ALERT SERVICE BULLETIN

SUBJECT: MAIN ROTOR SYSTEM - Swashplate

Removal of the swashplate bellows and retrofit of the deflection ring of the swashplate

Revision No.	Date of issue	
Revision 0	2014-03-31	
Revision 1	2014-08-04	
Revision 2	2015-07-30	
Revision 3	2016-02-08	
Revision 4	2016-05-23	
Revision 5	2017-07-25

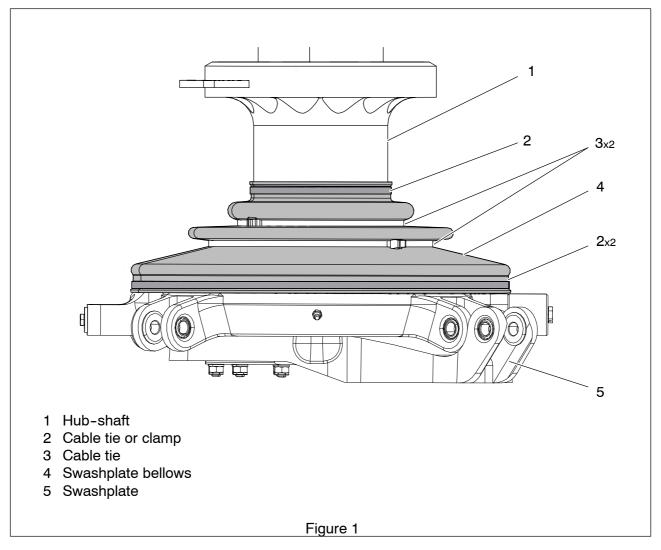
(a) Remove the cable ties or clamps (2, Fig. 1) and cable ties (3) from the swashplate bellows (4).

- (b) Remove the swashplate bellows (4, Fig. 1) from the swashplate (5) and from the hub-shaft (1).
- (c) Discard the swashplate bellows (4, Fig. 1).

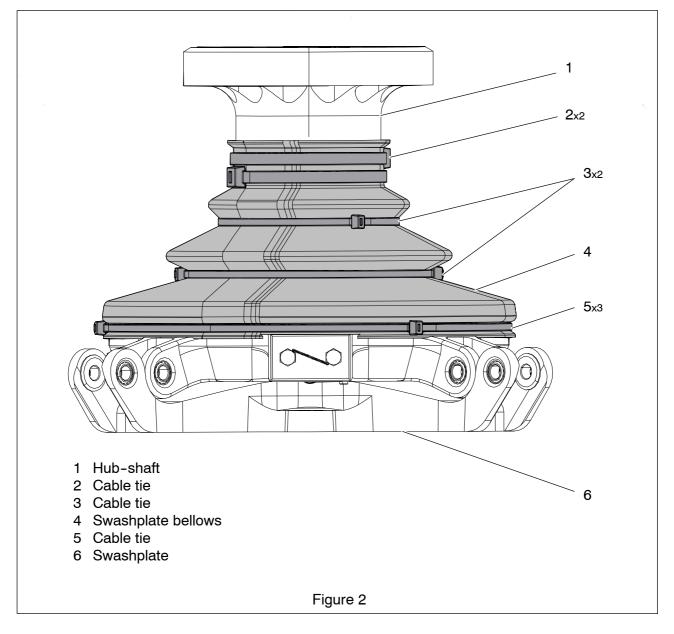
- (d) Remove the cable ties (2, Fig. 2), cable ties (3) and cable ties (5) from the swashplate bellows (4).
- (e) Remove the swashplate bellows (4, Fig. 2) from the swashplate (6) and from the hub-shaft (1).
- (f) Discard the swashplate bellows (4, Fig. 2).

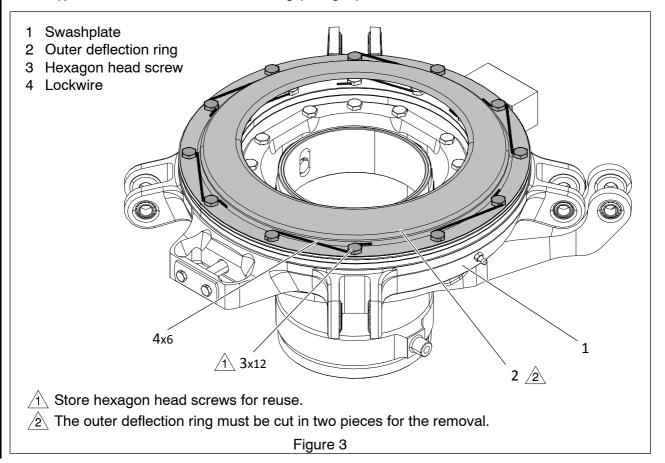
- (a) Remove the lockwire (4, Fig. 3) from the hexagon head screws (3).
- (b) Remove the twelve hexagon head screws (3, Fig. 3) from the swashplate (1). Store the hexagon head screws (3) for reuse.

- (c) Protect the swashplate (1, Fig. 3) with a cloth.
- (d) Cut the outer deflection ring (2, Fig. 3) in two pieces using a metal snips or a suitable tool.
- (e) Remove the outer deflection ring (2, Fig. 3) from the swashplate (1).
- (f) Discard the outer deflection ring (2, Fig. 3).

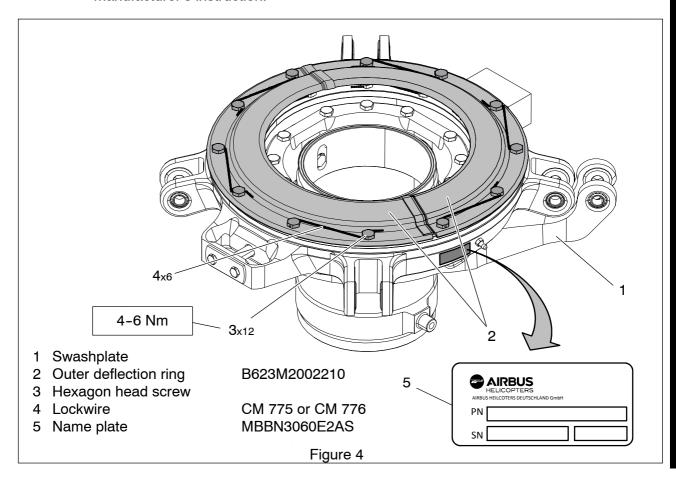
- (h) Position both parts of the new outer deflection ring (2, Fig. 4) on the swashplate (1), refer to Fig. 4.
- (i) Install both parts of the new outer deflection ring (2, Fig. 4) with twelve hexagon head screws (3). Torque the hexagon head screws (3) to 4-6 Nm (36-53 lbf.in).

- (j) Secure the Hexagon head screws (3, Fig. 4) with lockwire (4) (CM 775 or CM 776).
- (k) Write the P/N "B623M2002102" on the new name plate (5, Fig. 4) using a wiping resistant pen.

- (I) Copy the S/N from the old name plate to the new name plate (5, Fig. 4) using a wiping resistant pen.
- (m) Cross out the old P/N on the old name plate.

- (n) Apply a layer of lacquer (CM 481) to the old name plate. Let lacquer dry i.a.w manufacturer's instruction.
- (o) Install a new name plate (5, Fig. 4) close to the old name plate to the swashplate (1), refer to AMM, 11-00-00, 2-2.

- (p) Apply a layer of lacquer (CM 481) to the new name plate (5, Fig. 4). Let lacquer dry i.a.w manufacturer's instruction.

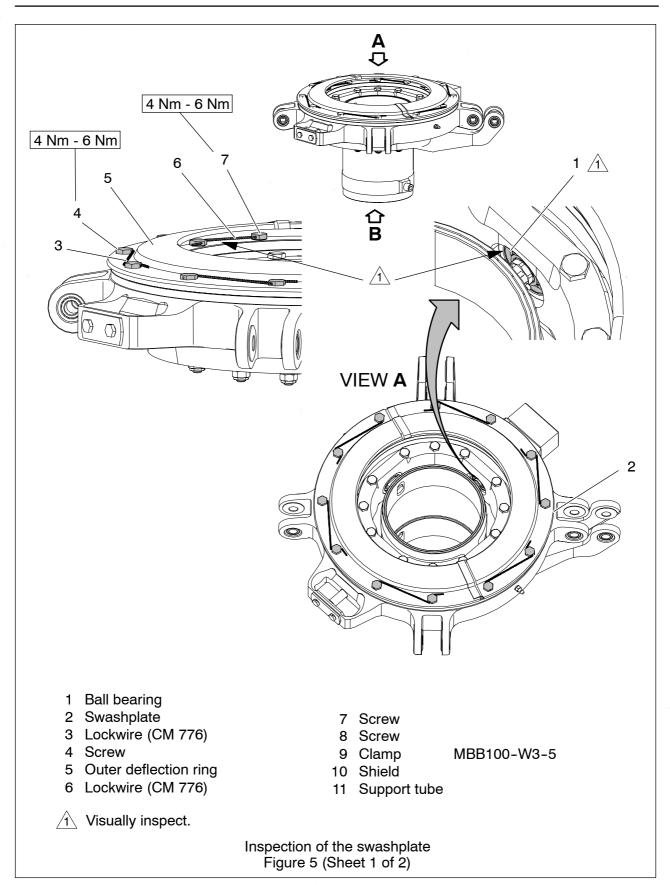
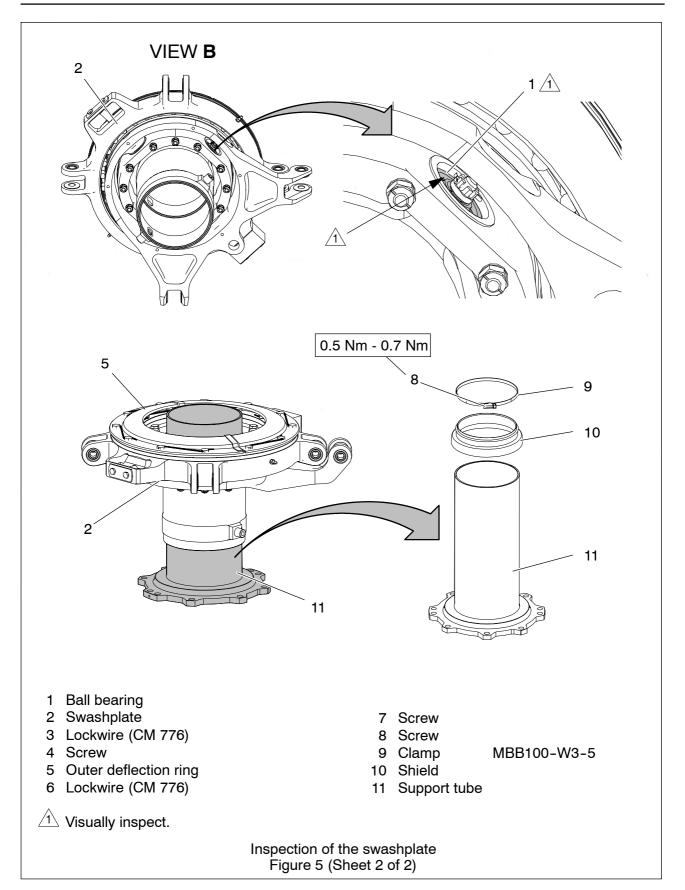
(h) Do the inspection of the support tube (11, Fig. 5) as follows:

In order to inspect the surface of the support tube (11, Fig. 5) use the collective lever to move the swashplate (2) up and down.

- 1 Clean the support tube (11, Fig. 5).
- <u>2</u> Examine the support tube (11, Fig. 5) for scratches.
 - If there are scratches, rework cylindrical area to a max. depth of 0.1 mm with polishing cloth #400. Reworked area must not exceed 10 mm in width, or 3 cm² in area. A minimum separation between any adjacent reworked areas must be 30 mm, and total reworked areas must not exceed 10 percent of the cylindrical area.

- (i) Do the inspection of the clamp (9, Fig. 5) for corrosion, damage and correct installation:
 - 1 Replace a corroded or damaged clamp (9, Fig. 5).
 - 2 If necessary install the clamp (9, Fig. 5) correctly on the shield (10).

- 3 Apply a torque between 0.5 Nm and 0.7 Nm to the screw (8, Fig. 5).
- (i) Do the inspection of the ball bearings (1, Fig. 5) as follows:
 - 1 Visually inspect the ball bearings (1, Fig. 5) for corrosion.

- 2 If the ball bearings (1, Fig. 5) show corrosion, contact AHD customer support.
- (k) Do the inspection of the area under the outer deflection ring (5, Fig. 5) as follows:

- 1 Remove the lockwires (3, Fig. 5) from the screws (4).
 - 2 Remove the screws (4, Fig. 5).
 - 3 Remove the outer deflection ring (5, Fig. 5).
 - 4 If there are foreign objects, remove the foreign objects.

- 5 Remove dirt with a lint-free cloth.
 - 6 Lubricate the swashplate bearing, refer to AMM, 62-31-00, 3-1.
 - 7 Install the outer deflection ring (5, Fig. 5) with the screws (4).

- 8 Apply a torque between 4 Nm and 6 Nm to the screws (4, Fig. 5).
 - <u>9</u> Safety the screws (4, Fig. 5) with new lockwire (CM 776) (3), refer to MTC, 20-02-06-402.

- (a) Do the inspection of the swashplate bearing, refer to AMM, 62-31-00, 6-2.
- (b) Lubricate the swashplate bearing, refer to AMM, 62-31-00, 3-1.
- (c) Do the inspection of the area under the outer deflection ring (5, Fig. 5) as follows:
 - 1 Remove the lockwires (3, Fig. 5) from the screws (4).
 - 2 Remove the screws (4, Fig. 5).
 - 3 Remove the outer deflection ring (5, Fig. 5).
 - 4 If there are foreign objects, remove the foreign objects.
 - 5 Remove dirt with a lint-free cloth.
 - 6 Install the outer deflection ring (5, Fig. 5) with the screws (4).
 - 7 Apply a torque between 4 Nm and 6 Nm to the screws (4, Fig. 5).
 - 8 Safety the screws (4, Fig. 5) with new lockwire (CM 776) (3), refer to MTC, 20-02-06-402.
